TOWN OF JACKSON BOARD OF ADJUSTMENT AGENDA DOCUMENTATION

PREPARATION DATE: MAY 31, 2019
MEETING DATE: JUNE 5, 2019

SUBJECT: **ITEMS P19-085:** REQUEST FOR A VARIANCE FROM THE CURB CUT STANDARD IN THE NEIGHBORHOOD LOW DENSITY-5 (NL-5) ZONING DISTRICT FOR THE PROPERTY LOCATED AT 610 HALL AVENUE

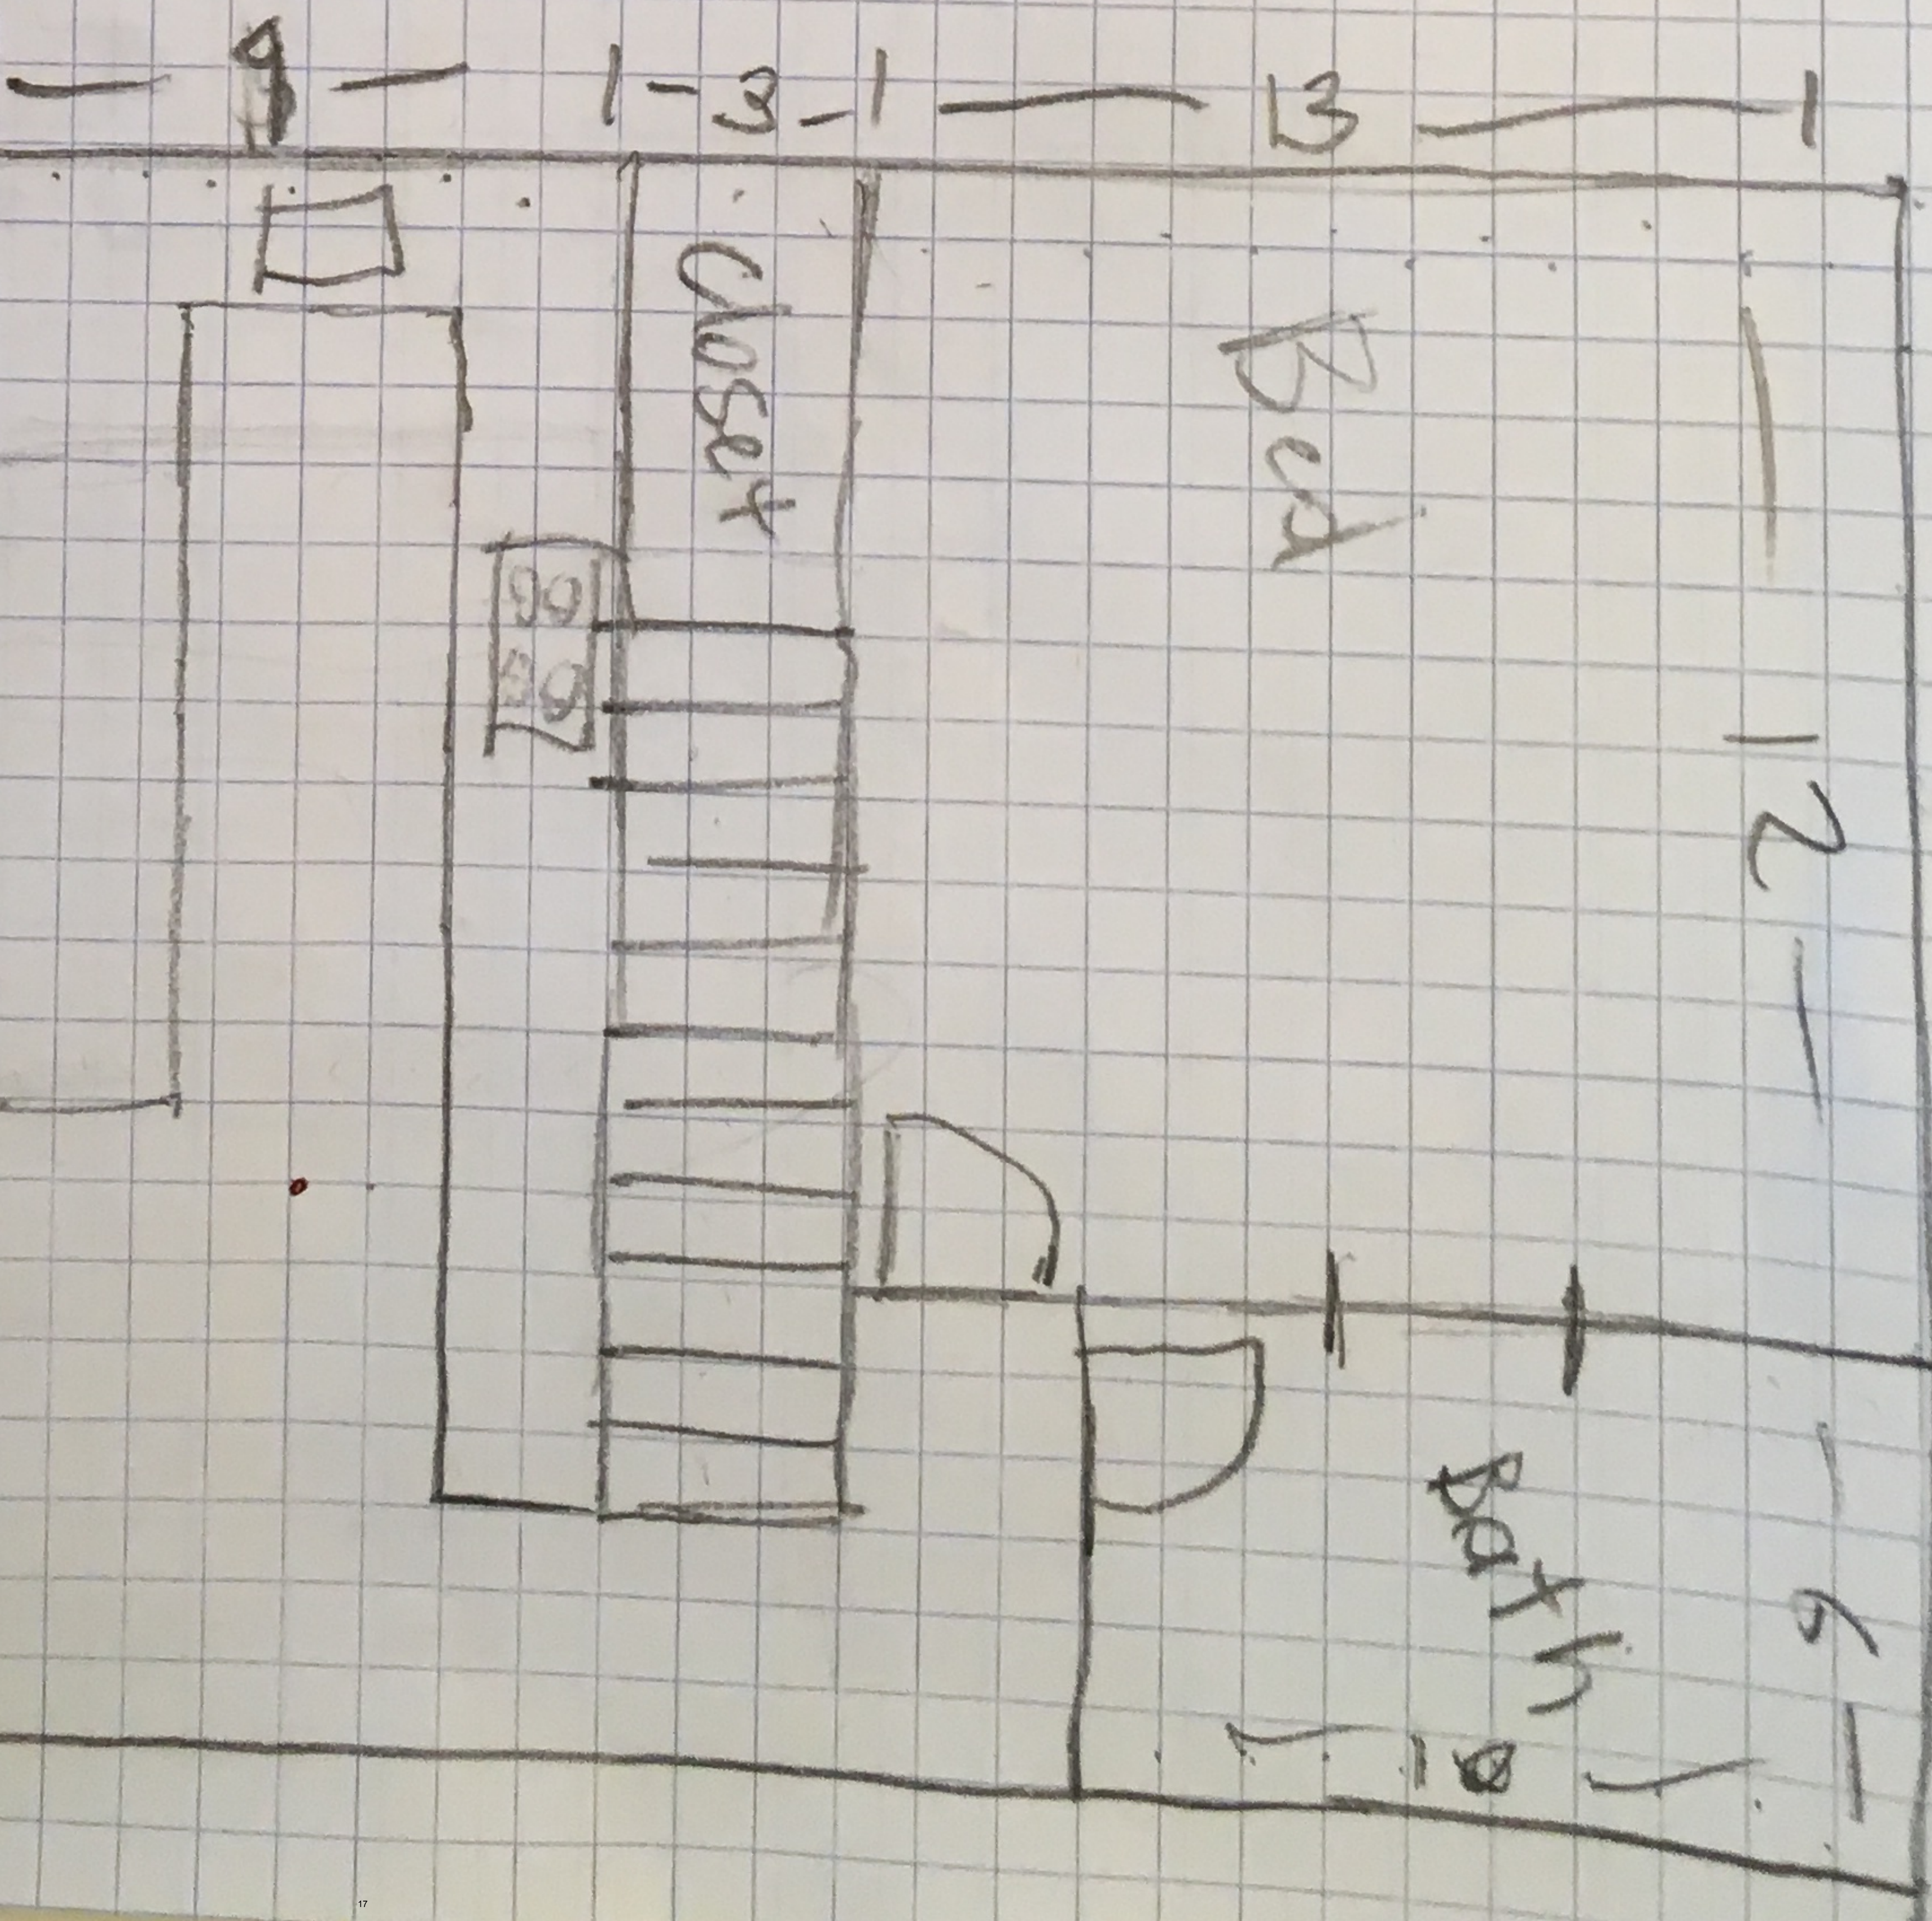
- Ensure that the driveway is graded to an elevation that will allow for a possible future sidewalk along Hall St. The elevation should be such that the sidewalk could be a detached continuous sidewalk (so that the sidewalk is continuous across the driveway across at the same height or higher than the back of curb, approximately 6").

1. The number of curb cuts shall be limited to two (2) with a maximum width of twenty (20) feet.
2. Setback from the surveyed corner should not be less than the ten (10) feet shown on the propose plans.
3. Development of the lot frontage should consider the Hall Ave. frontage as two (2) fifty feet wide lots and conform to the development standards as though there was two lots.
4. No vehicular access to Redmond Street is allowed.
